Staff Report

**Coal Seam
Preliminary/Final PUD, Lot Split, and Variance Application
Resolution PZ 2025-02
Planning & Zoning Commission (P&Z) – May 28th, 2025**

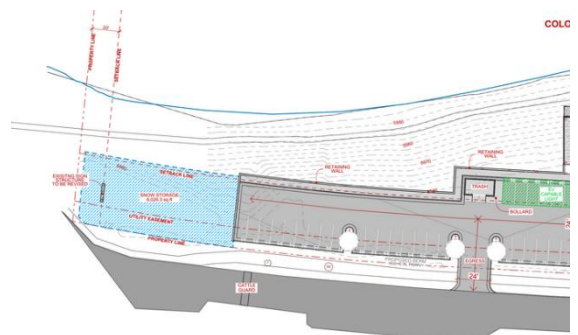
Because of the shortage, the Applicant has requested consideration of a shared parking plan (**Exhibit E, page 321**). A shared parking arrangement is not unprecedented in New Castle. The Lakota Longview application (Romero), for instance, allowed for a 40% reduction in required parking. There the shared parking arrangement was supplemented by yearly audits, performance measures, and mitigation strategies in case the arrangement was ineffective.

In the case of Coal Seam, the parking reduction stands at only 21%. However, a shared parking arrangement at this location could still prove challenging. Shared parking arrangements trade on an equilibrium of peak times among the various uses in a location. For example, office uses generally have offsetting peak times to residential uses, allowing for office users to occupy nearby residential spaces when those residents are off to work elsewhere. Or, restaurant users may occupy office parking at night when offices are closed. The peak parking times balance making shared parking a reasonable way to lower capital expenses, minimize maintenance, and reduce parking lot sprawl.

With Coal Seam, the intended uses all lend themselves to evening parking (with retail as a possible exception). Hotel, residential, and restaurant parking all skew towards evening peaks leaving patrons of these establishments to compete for limited spaces. Moreover, even if the hotel is only 65% occupied, as the application maintains, hotel users will still need to share 5 spaces from the other businesses. All of this may be acceptable if alternatives were available nearby – e.g. on-street parking or parking at Grand River Park. The Town has floated an idea to Balcomb/City Market management about the possibility of sharing 15-30 spaces in their lot. Their response was understandably tepid. If considered, the arrangement would require an available shuttle by the hotel. As a result of these concerns, P&Z should be absolutely clear of the provisions for shared parking and fully confident in a contingency plan if the strategy proves problematic.

- J. A parking management plan shall be added to the covenants prior to final approval with provisions for reserved parking for the residential units.
- K. A subdivision improvements agreement ("SIA") containing an engineer's stamped cost estimate of public improvements, to the satisfaction of the Town Attorney. The form of the SIA shall be finalized before consideration of the Application by the town council. Recordation of the SIA shall be accomplished at or before recording of the Final Plat.
